| APPLICATION NO. | FILING DATE | FIRST NAMED INVENTOR | ATTORNEY DOCKET NO. | CONFIRMATION NO. |
|-----------------|-------------|----------------------|---------------------|------------------|
| 10/620,575 | 07/17/2003 | Jang-Jin Yoo | 8733.418.10 | 8871 |

Office Action Summary

DETAILED ACTION

FIG. 3

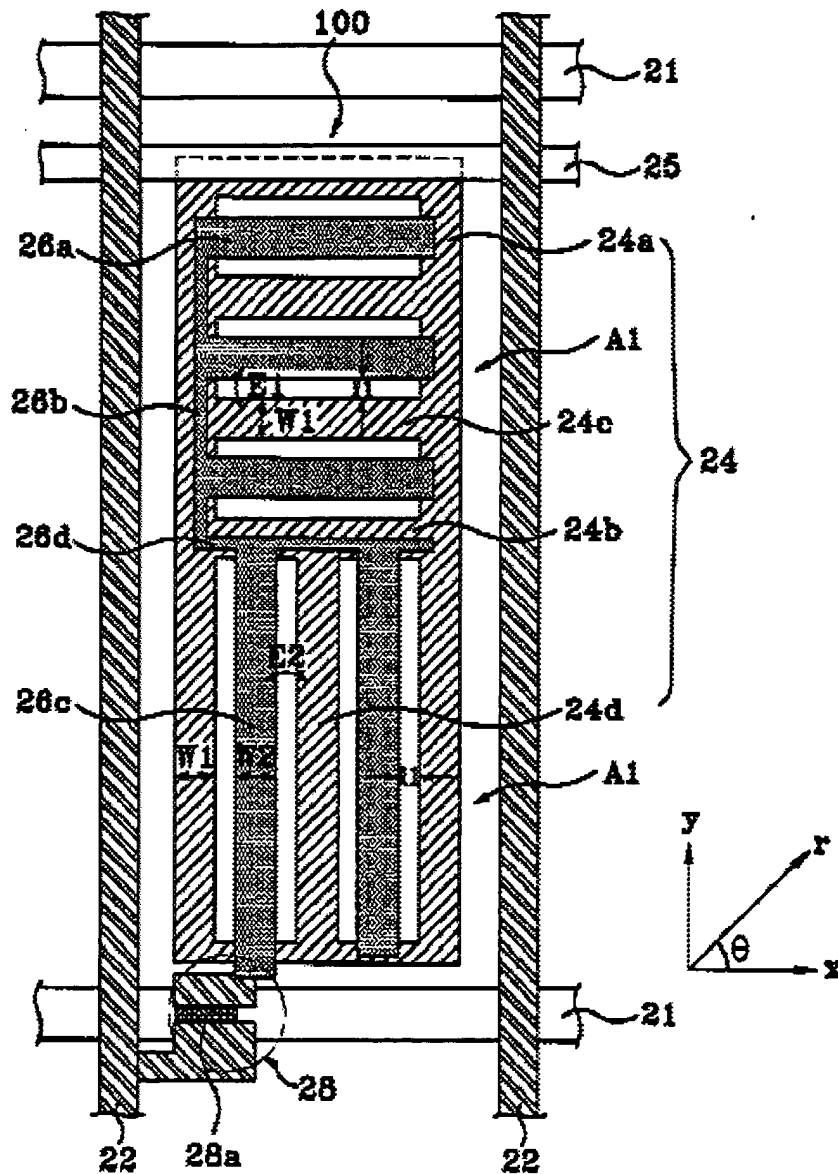
As to claim 18, Lee discloses (Abstract, Title, entire patent and first embodiment) an array substrate for an IPS-LCD device (col. 6, line 35 through col. 9, line 54), comprising:

a substrate; a gate line, 21, on the substrate; a data line, 22, perpendicular to the gate line; a thin film transistor, 28, at a crossing portion between the gate and data lines; a common line, 25, parallel to the gate line; a plurality of common electrodes, 24d, 24a,

and its counterpart on the left, extending perpendicular to the common line, the plurality of common electrodes being divided into first and second portions of respective first and second domains [multiple common electrode portions in upper and lower domains]; a plurality of pixel electrodes, 26c and 26b, arranged alternately with the plurality of common electrodes, the plurality of pixel electrodes being divided into first and second portions of the respective first and second domains [multiple pixel electrode portions in upper and lower domains]; an auxiliary common electrode, 24c, perpendicularly contacting each of the common electrodes; and an auxiliary pixel electrode, 26d, perpendicularly contacting each of the pixel electrodes; wherein the auxiliary pixel electrode is spaced apart from the auxiliary common electrode; and the pixel electrodes are on a same layer as said auxiliary pixel electrode.

As to claim 19, Lee discloses (Abstract, Title, entire patent and first embodiment) an array substrate for an IPS-LCD device (col. 6, line 35 through col. 9, line 54), comprising: a substrate; a gate line, 21, on the substrate; a data line, 22, perpendicular to the gate line; a thin film transistor, 28, at a crossing portion between the gate and data lines; a common line, 25, parallel to the gate line, the common line including first and second auxiliary common lines, 24d, 24a, and its counterpart on left, perpendicular to the common line; a plurality of common electrodes, 24b and 24c, extending perpendicular to the first and second auxiliary common lines, the plurality of common electrodes being divided into first and second portions of respective first and second domains [multiple common electrode portions in upper and lower domains]; a plurality of

pixel electrodes, 26a and its counterparts, arranged alternately with the plurality of common electrodes, the plurality of pixel electrodes being divided into first and second portions of the respective first and second domains [multiple pixel electrode portions in upper and lower domains]; an auxiliary common electrode, 24a (dual purpose), perpendicularly contacting each of the common electrodes; and an auxiliary pixel electrode, 26b, perpendicularly contacting each of the pixel electrodes, wherein the auxiliary pixel electrode is spaced apart from the auxiliary common electrode.

As to claim 20, Lee discloses (Abstract, Title, entire patent and first embodiment) an array substrate for an IPS-LCD device (col. 6, line 35 through col. 9, line 54), comprising: a substrate; a gate line, 21, on the substrate; a data line, 22, perpendicular to the gate line; a thin film transistor, 28, at a crossing portion between the gate and data lines; a common line, 25, parallel to the gate line, the common line including a plurality of common electrodes, 24d, 24a, and its counterpart on the left, extending perpendicular to the common line; a plurality of pixel electrodes, 26c and its counterpart on the right, arranged alternately with the plurality of common electrodes; and a plurality

of auxiliary electrodes, 24b, 24c, and 26d, connecting the plurality of common and pixel electrodes to form a multi-domain having a check pattern.

FIG. 10

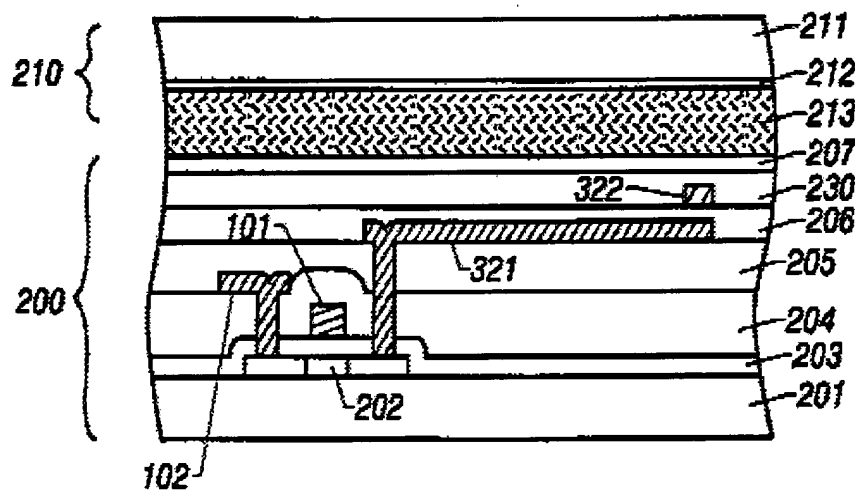
Hirakata teaches in the fourth embodiment (col. 8, line 56 through col. 9, line 34) a dielectric film, 205 (Applicant's first passivation layer), over the gate insulating layer, the data line and thin film transistor; a plurality of pixel electrodes, 321, on the first passivation layer; a second dielectric film, 206 (Applicant's second passivation layer), over the pixel electrodes; a common line, 322, on the second passivation layer to comprise a structure with increased aperture ratio (col. 8, lines 57-59).

Hirakata is evidence that ordinary workers in the art of liquid crystals would find the reason, suggestion, or motivation to add a first passivation layer over the gate insulating layer, the data line and thin film transistor; a plurality of pixel electrodes on the first passivation layer; a second passivation layer over the pixel electrodes; a common

Therefore, it would have been obvious to one having ordinary skill in the art of liquid crystals at the time the invention was made to modify the LCD of Lee with the first passivation layer over the gate insulating layer, the data line and thin film transistor; a plurality of pixel electrodes on the first passivation layer; a second passivation layer over the pixel electrodes; a common line on the second passivation layer of Hirakata to comprise a structure with increased aperture ratio.

FIG. 7

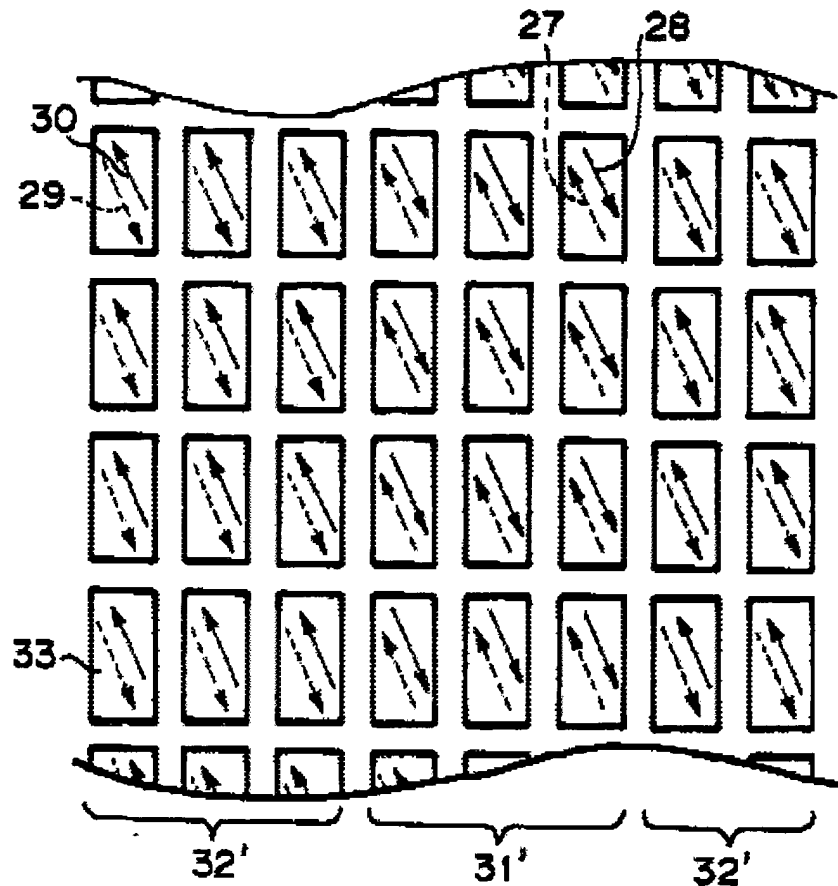
Okamoto teaches (Abstract, Title, entire patent) an alignment layer having first and second rubbing directions, the first and second rubbing directions corresponding to the first and second domains, respectively (col. 3, lines 25-59) to enhance image quality by preventing dependence on the viewing angle in the vertical and right-and-left directions.

Okamoto is evidence that ordinary workers in the art of liquid crystals would find the reason, suggestion, or motivation to add an alignment layer having first and second rubbing directions, the first and second rubbing directions corresponding to the first and second domains, respectively, to enhance image quality by preventing dependence on the viewing angle in the vertical and right-and-left directions.

Please note that rubbing directions are relative to other variables of design, including polarizer angles and retarder angles. Therefore, it would be well known to those having ordinary skill in the art of liquid crystals at the time the claimed invention was made to arrange the rubbing directions to be symmetrical about a line parallel to the gate line as a function of polarizer angles and retarder angles.

FIG. 5A

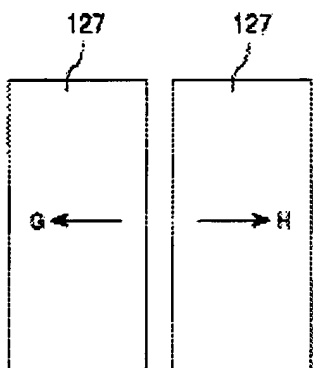
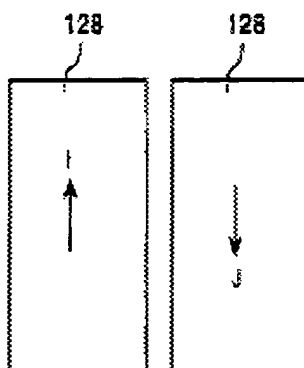
Chen teaches (Abstract, Title, entire patent, Figures 5A and 5B) an alignment layer having first and second rubbing directions, the first and second rubbing directions corresponding to the first and second domains, respectively to enhance image quality by preventing dependence on the viewing angle in the vertical and right-and-left directions with a process as simple as possible [abstract].

Please note that one of the two illustrated arrangements of Chen would be symmetrical about a line parallel to the gate line regardless of whether the gate line runs up and down, or left and right.
